CONTRACTOR: M.A. WOGAN
 CIVIL BEND - COPELAND BEND CONTRACT NO. W643 eng-56

CONTRACTOR: M.A. WOGAN
 COPELAND BEND CONTRACT NO. W643 eng-55

COPELAND BEND HIRED LAB

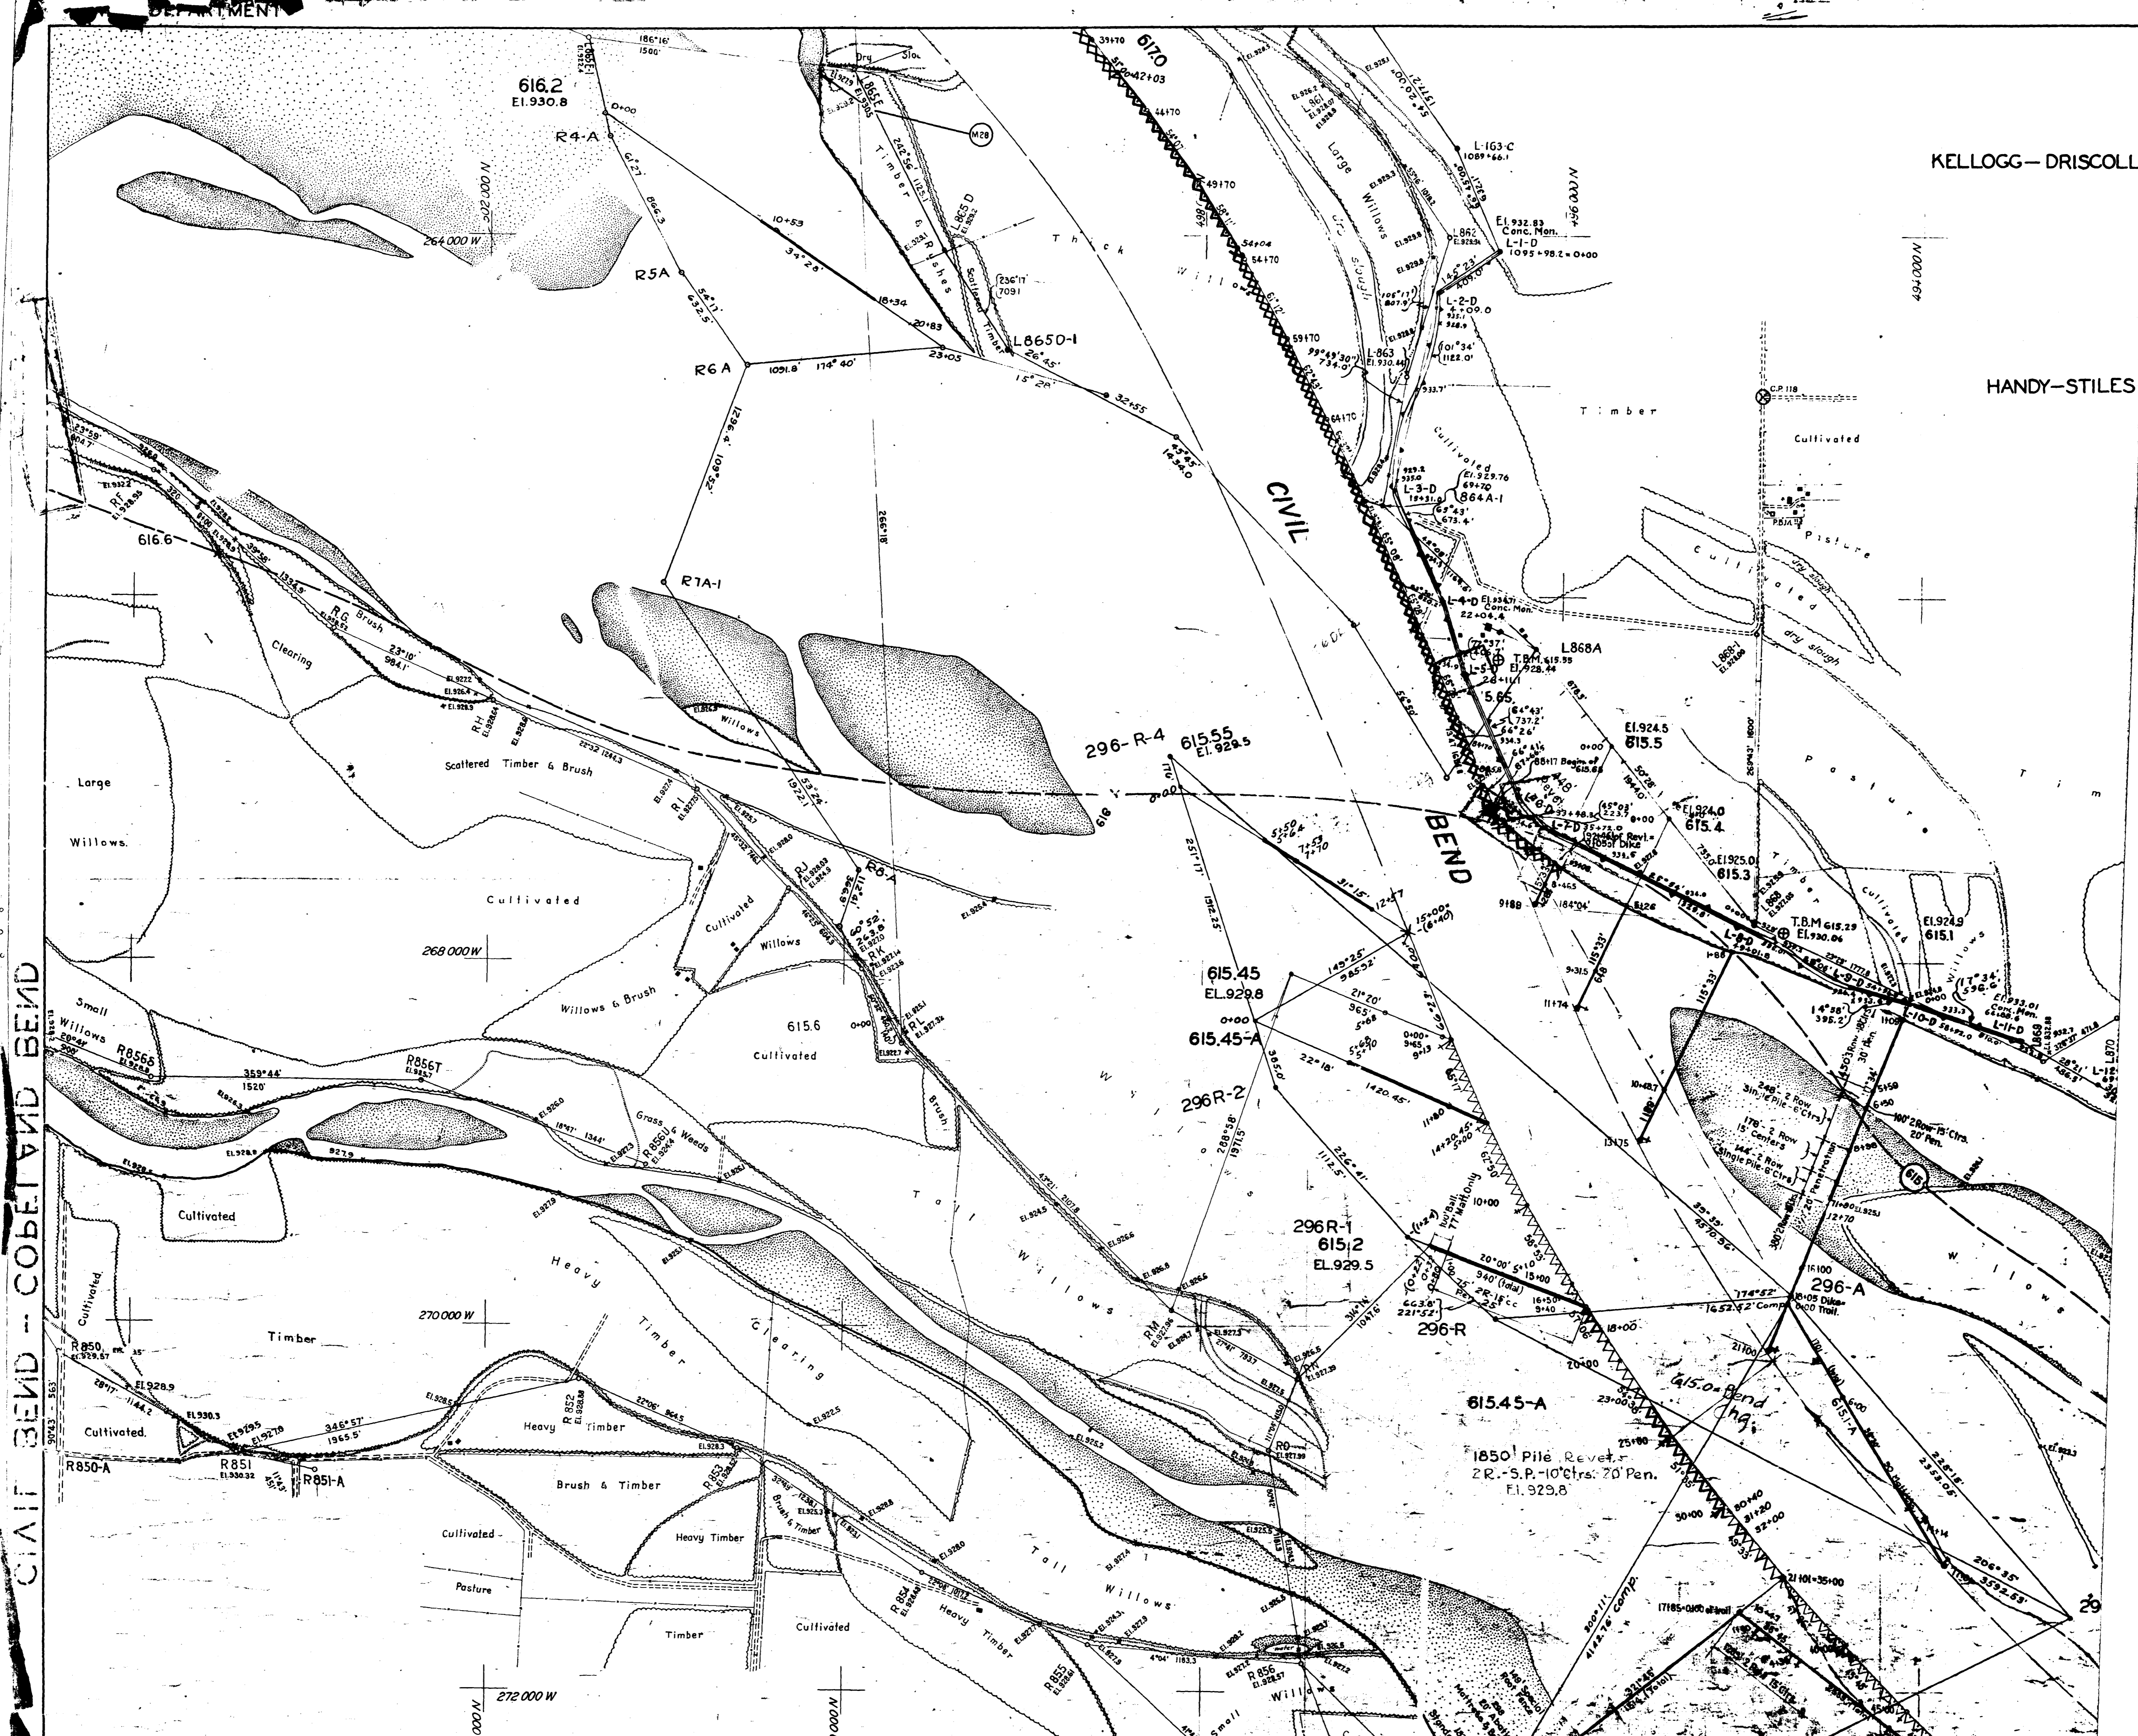
Revised: May 26, 1936; showing recession of Marker Clumps on Trail Dike, 615.1-A, at Stations 1114, 614.5+14 & 214.

REVISIONS:
 Aug. 1934 showing Revelment 615.65 L.B. & Dikes 615.5, 615.4, 615.3, 615.1, 614.7-A, 614.7-B, L.B. and 614.9, 614.9-A, R.B. authorized for construction.
 Oct. 23, 1934 showing change in strength of Dike 615.1 L.B. to conform to letter of even date.
 Oct. 31, 1934 showing change in layout of Dike 614.7 L.B., also Dike 615.1-A L.B. authorized for construction.
 Nov. 19, 1934 showing elevation of Dikes 615.3 & 615.1 L.B. changed to conform to letter of even date.
 Feb. 20, 1935 showing elevation of Dikes 614.7-A & 614.7-B L.B. changed to conform to letter of even date.
 March 18, 1935 showing elevation of Dikes 614.7-A & 614.7-B L.B. changed to conform to letter of even date.
 March 29, 1935 showing strength for Dike 614.7 L.B. changed to conform to letter of even date.
 April 4, 1935 to show change in length, strength & elevation of Dike 614.9 R.B. and change in elevation of Dike 615.1-A L.B.

April 18, 1935 showing elevation of Dike 614.9-A R.B. changed to conform to letter of even date.
 Aug. 14, 1935 showing penetration of Dike 615.1-A L.B. changed to conform to letter of even date.
 Oct. 21, 1935 showing penetration of Dike 614.7-A L.B. changed to conform to letter of even date.
 May 15, 1936 showing recession of Revelment 615.65 L.B. from sta. 82165 to sta. 88417 to conform to letter of even date.

REVISIONS:
 Aug. 10, 1934 showing Revelment 613.4 R.B. & Dike 612.6 L.B. authorized for construction.
 Aug. 20, 1934 to show changed alignment and length of Revelment 613.4 R.B. & changed length of Dike 612.6 L.B.
 Sept. 19, 1934 to show changed alignment of Revelment 613.4 R.B. to conform with letter of even date.
 Oct. 15, 1934, showing changed strength for Dike 612.6 L.B. to conform to letter of even date.
 April 3, 1935 showing 3633' of additional treatment authorized for construction of Mile 613.4 R.B.
 April 19, 1935 showing changed alignment of Revelment 613.4 R.B. from sta. 0100 to sta. -136191); also Standard Revelment changed to Pile Revelment from sta. -45175) to sta. -261483).
 Mar. 24, 1936 showing recession of Revelment 613.4 R.B. sta. -136191) to sta. -136190) rescinded.

REVISIONS:
 April 5, 1935 to show Abatis 614.9 R.B. authorized for construction.
